# CITY OF ALBUQUERQUE

**RE: Desert Ridge Pointe Subdivision  
Grading & Drainage Report/Plan  
Engineer's Stamp Date 9-6-2016  
Report Dated 8-29-2016 (File: B19D028)**

# DESERT RIDGE POINTE SUBDIVISION

**RE: Desert Ridge Pointe (a.k.a Glendale Townhomes)**  
**Grading and Drainage Plan**  
**Engineer's Stamp Date 3-22-2016 (File: B19D028)**

DESERT RIDGE POINTE  
CONCEPTUAL GRADING & DRAINAGE PLAN

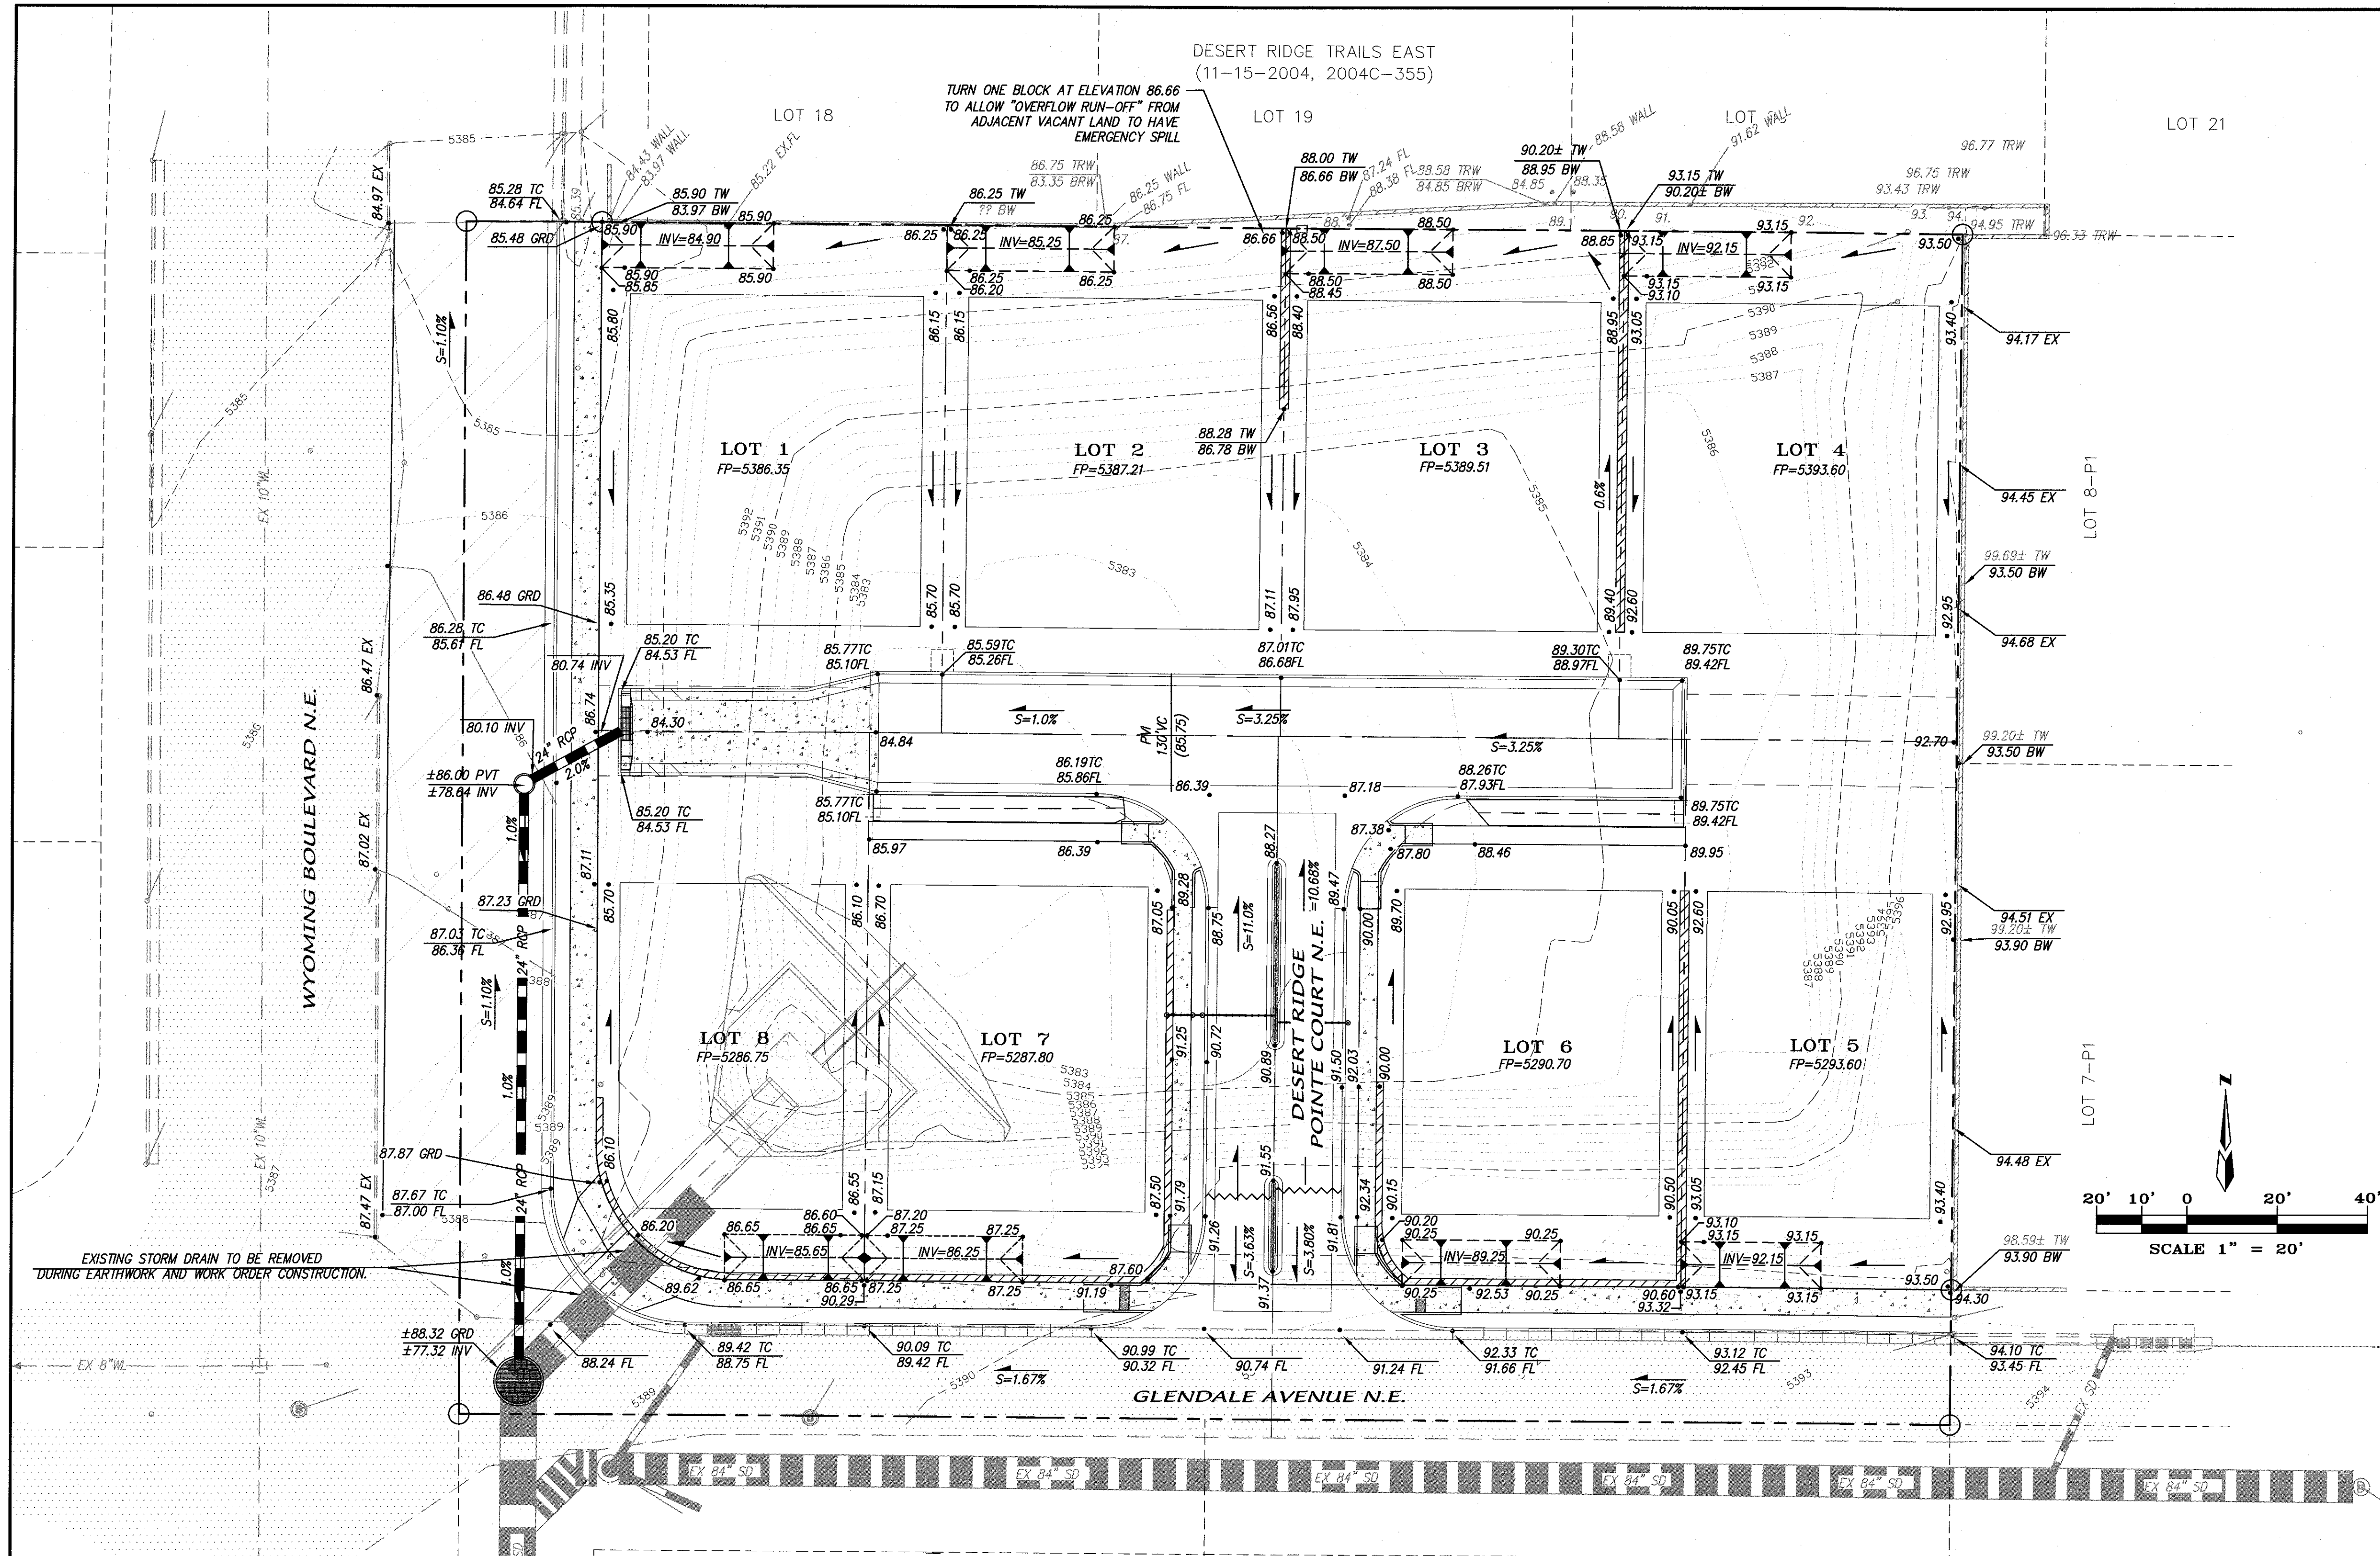
1. Since this site is within Basin 204 of the NAA MDP which discharges to the 96" Storm Drain in Wyoming at Glendale, this site must discharge to this Storm Drain. The outfall shown is a Sidewalk Culvert discharging to Wyoming, and contours show that it would flow north to a different outfall which may not have capacity.
2. The 84" Storm Drain in Glendale is deep, and therefore it is anticipated that a Storm Drain in Wyoming, north of Glendale will have enough fall to tie into the existing system.
3. The land treatments must be limited to those in the NAA MDP. For this basin it was 20% A, 20% B, 34% C, 26% D
4. The First Flush must be addressed.

**Since these comments will likely affect the overall drainage concept, a detailed review will not be done at this time.**

On August 25, 2016, the owners and myself met with Abiel to discuss an alternative option for the "first flush" volume treatment. It was agreed that a portion of the backyard area could be used to intercept the first flush volume. A revised "First Flush Volume Calculation" Exhibit has been added to the report. The back yard ponds have been added to the grading and drainage plan as well as a detail. Private backyard drainage easements will be added to each of the lots on the final plat.

1. The proposed storm drain connection to the existing storm drain in Glendale has been changed accordingly,
2. OK,
3. The treatment values referred to from the 1998 NAA MDP are typical values used for a 1 acre developed lot. Typical existing projects in this area have been allowed to develop at higher densities. This projects' density is consistent with the surrounding subdivisions. A comparison between the actual peak discharge (7.39 cfs) versus the peak discharge using the Land Treatment values found in the NAA MDP report sited (5.94 cfs), results in an increase of about 1.45 cfs. Given that runoff from this project will be discharging into an existing 84"-96" RCP storm drain, I would suggest that an overall increase of about 1.45 cfs is insignificant.
4. The "First Flush" volume has been calculated and addressed on the plan.
